Access Compliance Report

Public Rights-of-Way

(Curb Ramps)

Intersection ID: 8889	Main Street: BENNETT_ST	Cross Street: N_TRYON_ST	Location: NE
ADA ID: DEB866DD0373	Ramp Type: ParaDiag	Initial Pass/Fail: Fail	Overall Compliance: No
		Severity Score: 25

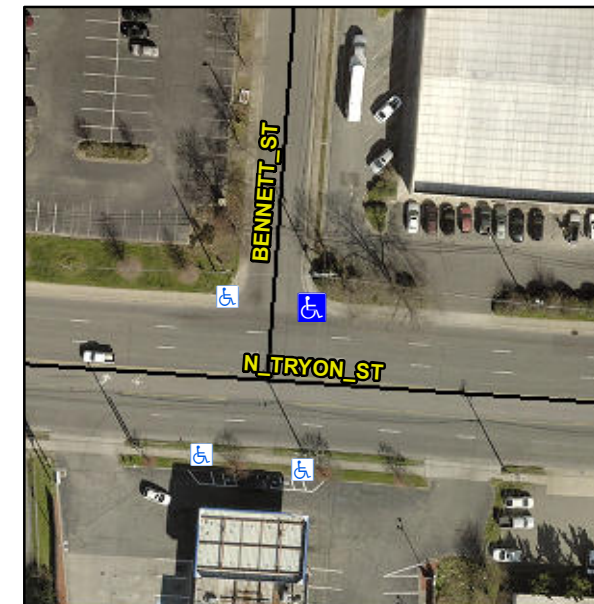
LT RP < 5%

R304.3.2

Remove & Replace Curb Ramp With Two New Directional Ramps or Equivalent.
